Petition Number: 2017-203

From: Kelsie Anderson, PE Reviewer: Carlos Alzate

**Revision Log:**

Figure 7: South Tryon Segment 1 Proposed Section (Near term)

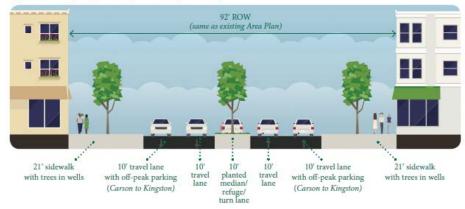
- 4. The recent South Tryon Corridor Study proposed a future cross-section that includes 7 foot raised bike lane. The petitioner should revise the site plan to show the future curbline as noted in Comment 1a for zoning purposes but construct the interim curbline at 25' from centerline and remove the future recessed parking on South Tryon St.
